Accessibility Audit

Holy Trinity Catholic School

Oakley Road
Small Heath
Birmingham
B10 0AX

13/07/2022

13.5
Cont.

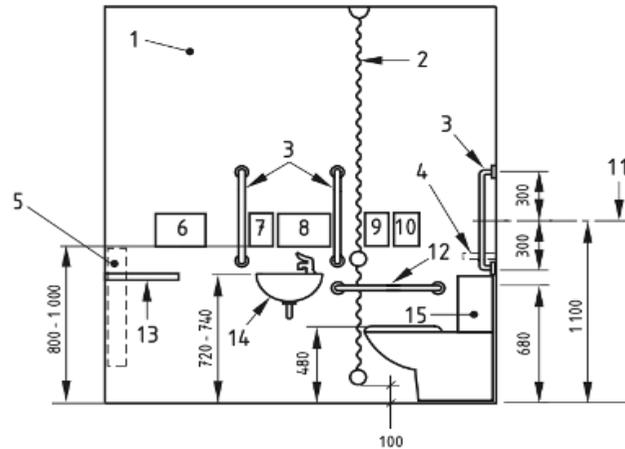
Height of drop-down support rails to be the same as the other horizontal grab rails.
